August 25, 2020

Jennifer Kaden, Associate Planner
City of Hood River

Subject: Applicant's additional written submission
Project: Adams Creek Cohousing, 1419 SE Sherman Ave, 03N10E35AA Tax Lot 4900

REVISED PRELIMINARY NORTH STORMWATER FACILITY
SITE PLAN REVIEW | 08/25/20
ADAMS CREEK COHOUSING

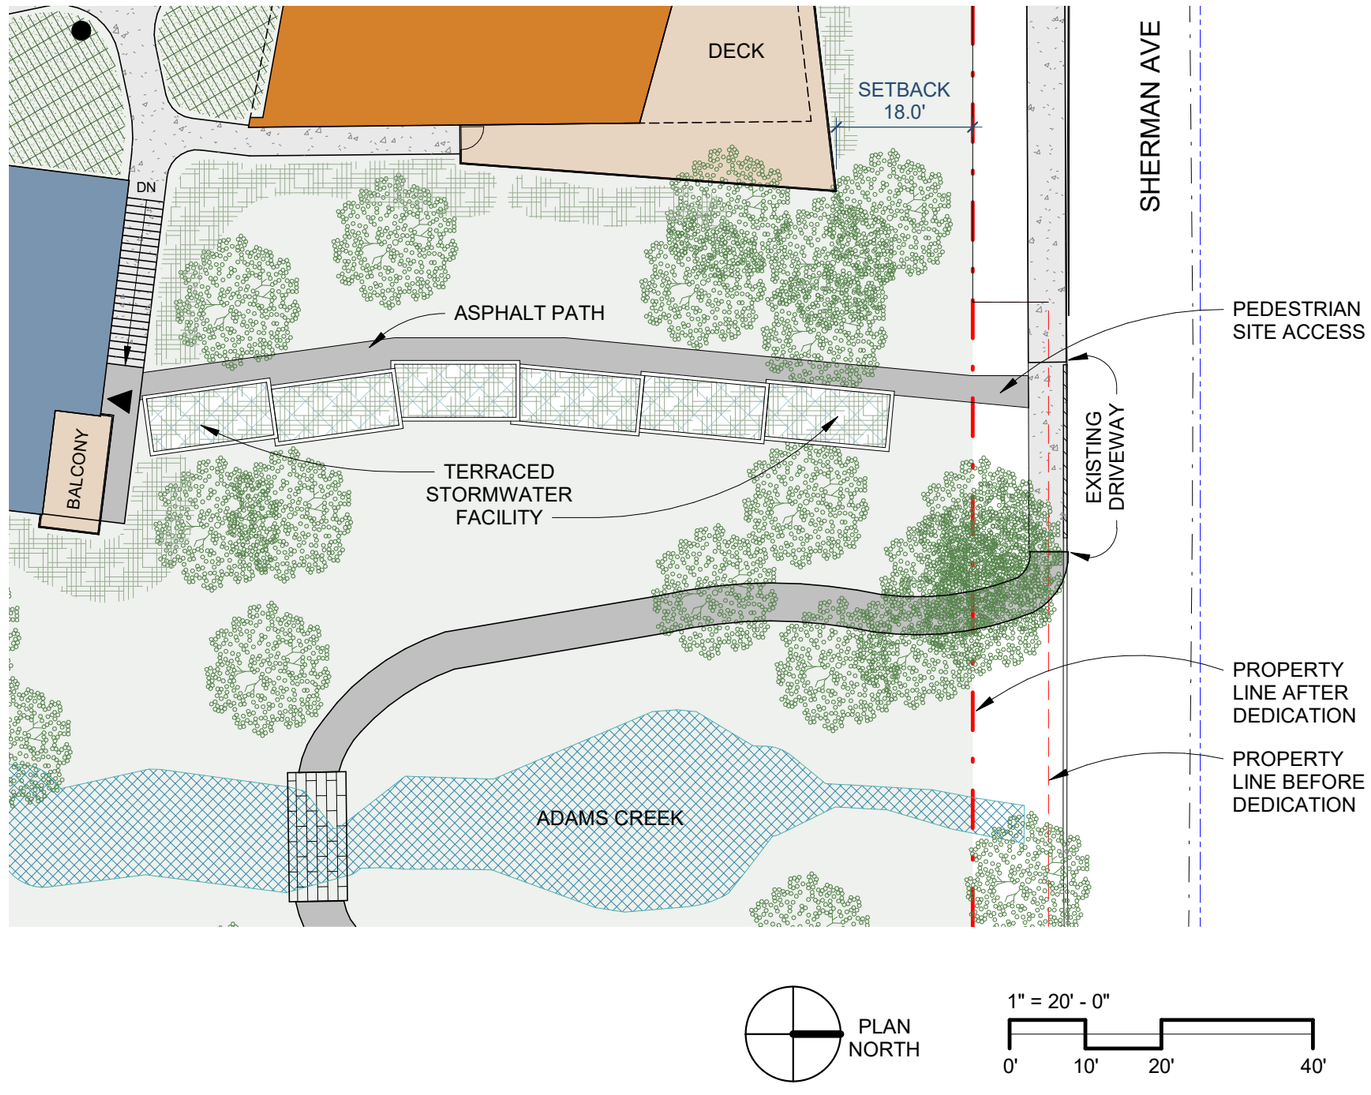
e. **Attachment 1f.** The primary audience for exhibits a. through e. is the City Engineer. Plan exhibit labeled "PR A1.2 rev1" graphically illustrates the design intent for the revision to the north facility. This exhibit – along with the narrative in this letter – is intended to describe the stormwater strategy for the Commission and community members who are less familiar with engineering terminology.

6 COVERED PARKING - WEST ELEVATION

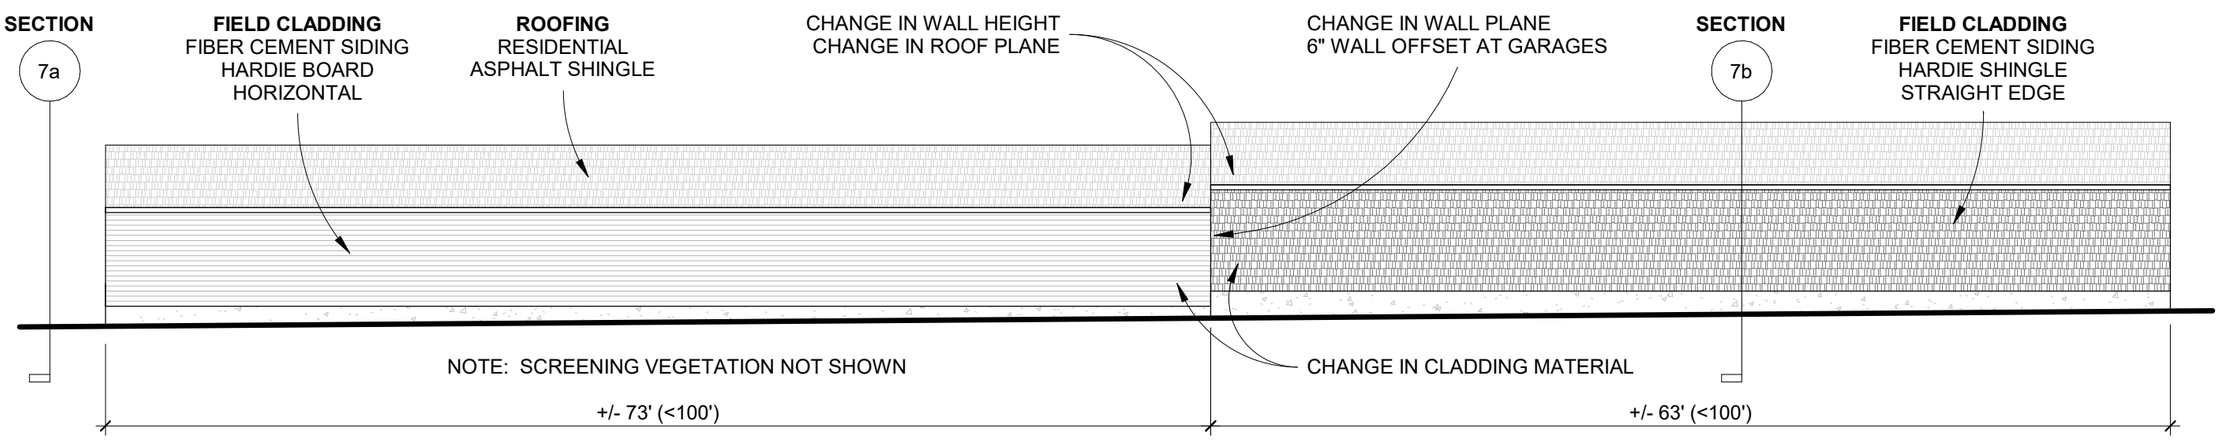
THIS DRAWING IS A REVISION TO DEMONSTRATE COMPLIANCE WITH HRMC 17.16.050.G
